PEER REVIEW STATEMENT

ATTENTION:	Tegan Cole, NSW Dept of Planning Industry and Environment (DPIE)	
FROM:	Hugh Middlemis, Principal Groundwater Engineer, HydroGeoLogic (HGL)	
REFERENCES:	7 October 2021	Mount Pleasant Optimisation Project (SSD 10418)(EPBC 2020/8735)
SUBJECT:	Mount Pleasant Optimisation Project Rehabilitation and Mine Closure. Targeted Peer Review of the Groundwater Impact Assessment Final Void Issues.

Figure 1 - Mt Pleasant conceptual final landform plan and section (after MACH 2021b, Figs. 7 & 8)

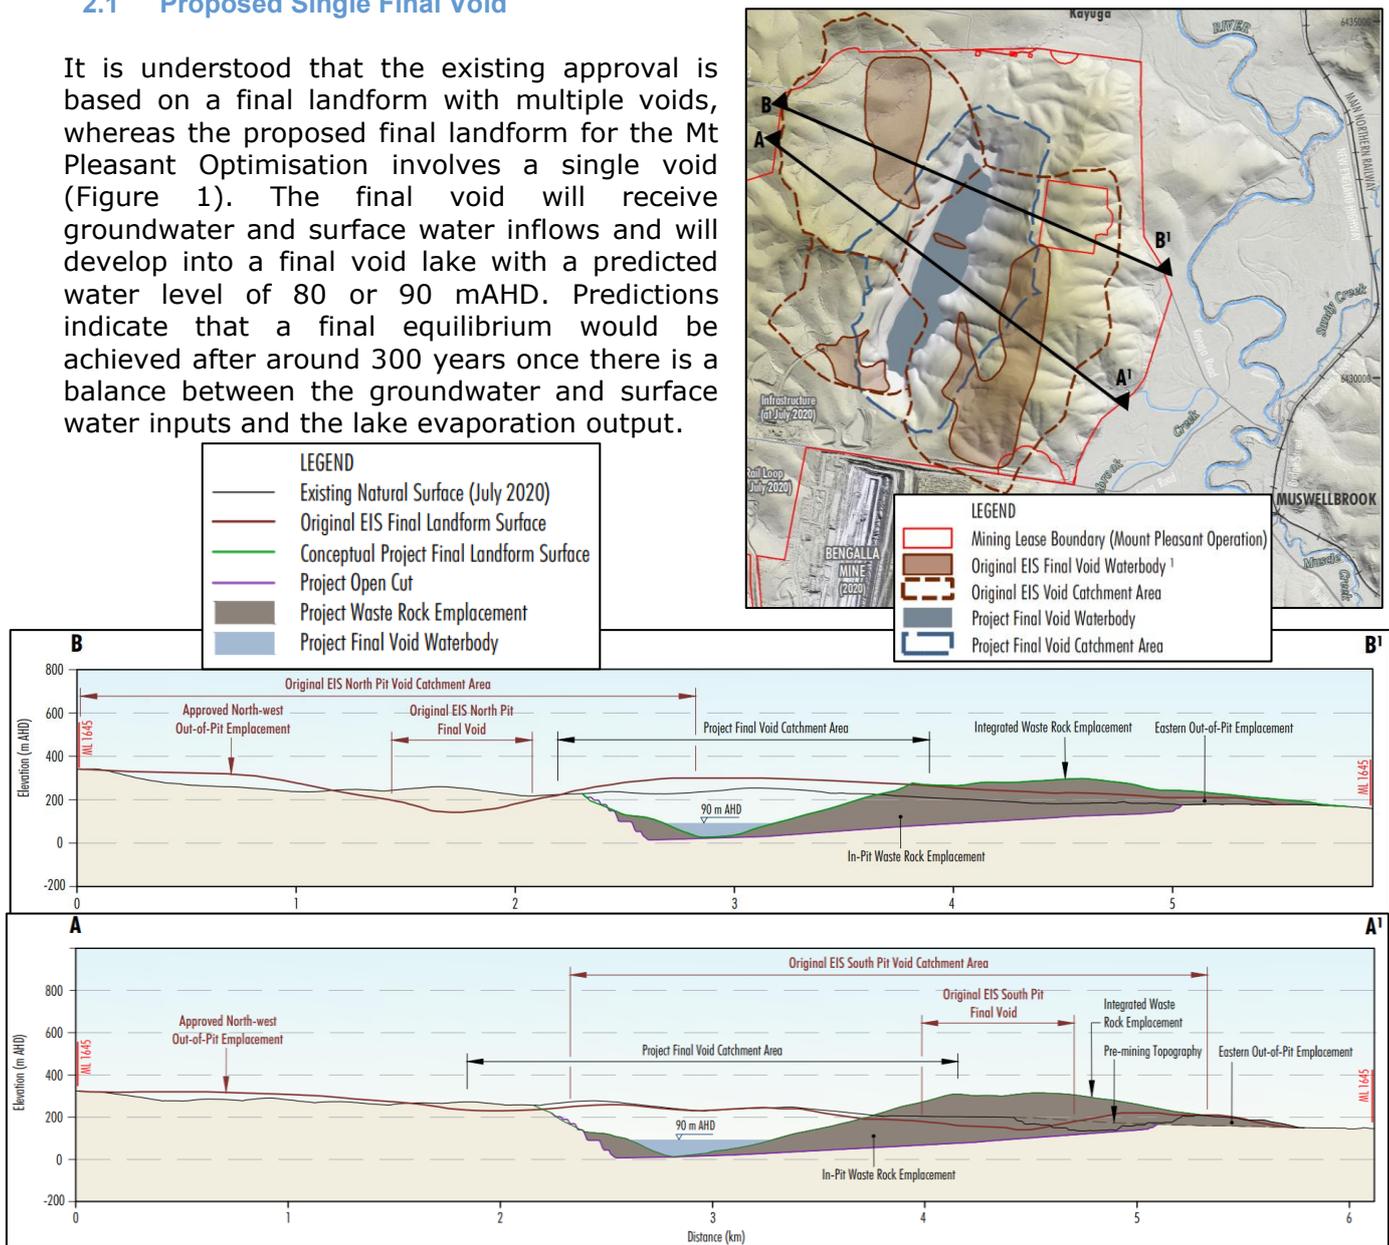
It is understood that the existing approval is based on a final landform with multiple voids, whereas the proposed final landform for the Mt Pleasant Optimisation involves a single void (Figure 1). The final void will receive groundwater and surface water inflows and will develop into a final void lake with a predicted water level of 80 or 90 mAHD. Predictions indicate that a final equilibrium would be achieved after around 300 years once there is a balance between the groundwater and surface water inputs and the lake evaporation output.

The single void appears to be an improvement in terms of a simple comparison of reduced footprint, which has implications for the final void lake equilibrium water level and water quality:

- reduced surface area of the void waterbody (162 ha compared to 435 ha)
- reduced catchment area (810 ha compared to 2050 ha).

The proposed single final void is deeper because the mining extends to deeper coal seams, which is more likely to result in a long term groundwater sink, as is reasonably predicted. Whether or not the proposed single final void will result in an improvement in water quality terms, compared to the multiple voids, is a complex question. It is not possible for this review to provide a definitive comparison, as that requires assessment of the catchment runoff inputs as well as the groundwater inputs and the evaporation effects, and a geochemical assessment. Nonetheless, this review considers that the final void lake water quality and geochemistry assessment is deficient in the sense that comprehensive details are not provided to clearly establish whether or not the final void lake would form a long term 'non-polluting' landform.

Figure 2 - Predicted final void lake level and salinity (after HEC 2020, Fig. 30)

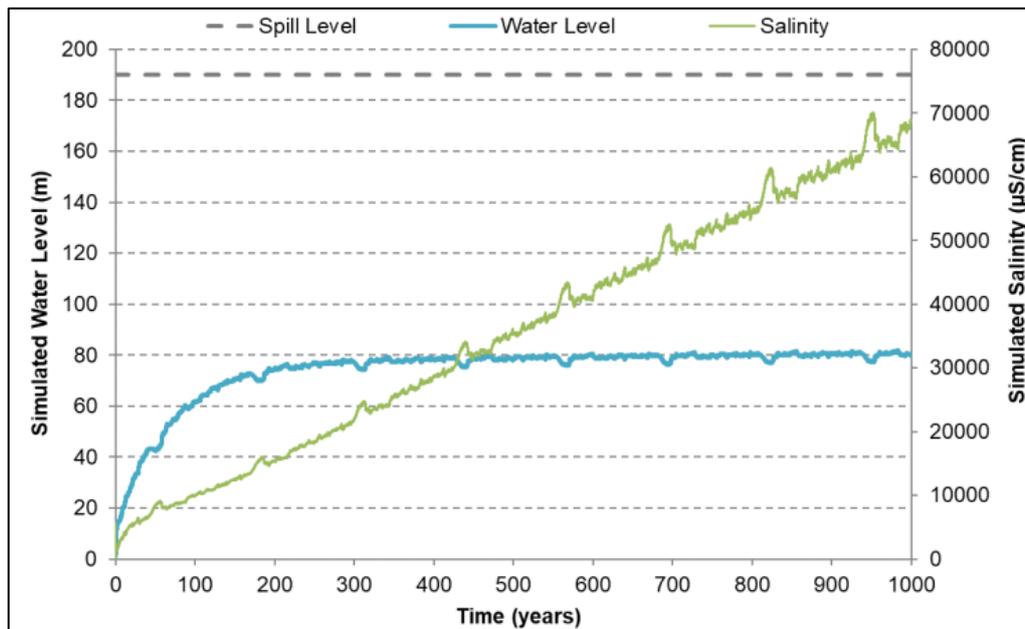
While the groundwater modelling details presented in the Groundwater Impact Assessment ('GIA'; AGE 2020a) are adequate and demonstrate consistency with best practice guidelines in general, the EIS report (MACH 2020a) and the supporting technical appendices present conflicting information on the long term lake level. The EIS states at section 7.8.3 (p.7-59) that the final void lake level is predicted to be 90 mAHD and illustrates this at Figure 7-16 (consistent with Figure 1 above). Figure A4.2 of the GIA also shows the final void lake level at 90 mAHD, but the similar Figure 30 in the Surface Water Impact Assessment ('SWIA'; HEC 2020) shows the predicted final void lake level at 80 mAHD (Figure 2). This inconsistency should be resolved.

In any event, the final void lake level is predicted to be well below the final void spill level at about 190 m. Although a parameter sensitivity analysis has not been presented for this analytical GoldSim water and salt balance model (HEC 2020), it is very likely that the level of the long term final void lake (as configured) would remain a groundwater sink well below the spill level, mainly due to the large area of the lake water surface and the relatively low inflows.

The Surface Water Impact Assessment ('SWIA'; HEC 2020) applies a GoldSim analytical water and salt balance model to predict that the final void lake salinity will increase linearly to about 70,000 EC after about 1000 years (see Figure 2 above). The existing groundwater quality is characterised by the inflow to the existing pit, which reportedly averages 5522 EC, and yet the post-mining final void lake salinity is predicted to be more than double that salinity after about 50 years, and to continue increasing to 70,000 EC (more than seawater) with no sign of abatement at 1000 years. This review finds it unreasonable to characterise the post-mining final void lake water quality as 'non-polluting', at least in the sense of it forming a potential source of poor quality water that is effectively a 'window' into the post-mining watertable.

- rationalise the conflicting information on the long term lake level (80 or 90 mAHD?);
- provide a sound explanation as to why the groundwater level versus inflow relationship that is used in the GoldSim analytical water and salt balance modelling (HEC 2020) is valid in showing increasing inflows between zero and about 50 mAHD, under conditions when the driving head for inflow is falling and thus inflows should be reducing; the explanation should also address why the maximum post-mining inflow is more than 1.5 times the maximum inflow predicted during mining;

Figure 3 - groundwater level and void inflow relationship (after HEC 2020, Fig. 29)

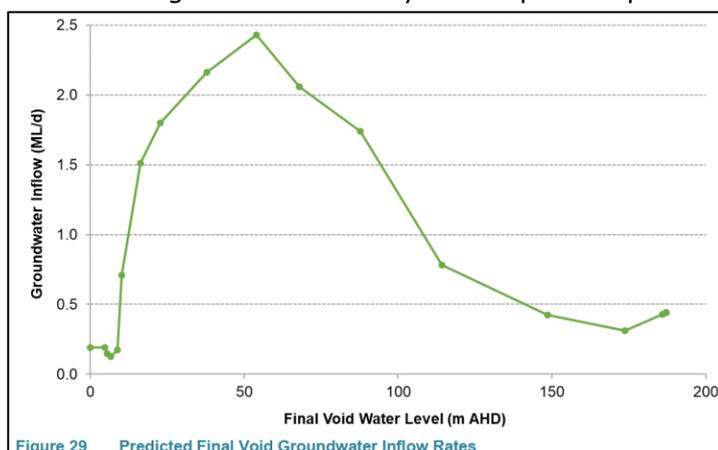
There is some confusing information presented in the reports. For example, the numerical groundwater model was used to define the relationship between groundwater level and inflow to the pit void, which was applied as one key input to the analytical GoldSim water balance, consistent with best practice. However, the plot of groundwater level versus inflow (Figure 3) exhibits a strange and unexplained relationship of increasing inflow between zero and about 50 mAHD (more than half-way up to the final equilibrium level shown in Figure 2 above), under conditions when the driving head for inflow is falling and thus inflows should be reducing (ie. as shown for the inflows below 2.5 ML/d on Figure 3 below, but also noting the maximum inflow during mining is about 1.6 ML/d; AGE 202a, Figure 9.1). The post-mining final void lake is not predicted to reach 50 mAHD until after about 60 years, which is a very long time for inflows to be increasing under some as yet unexplained process or undocumented modelling method.
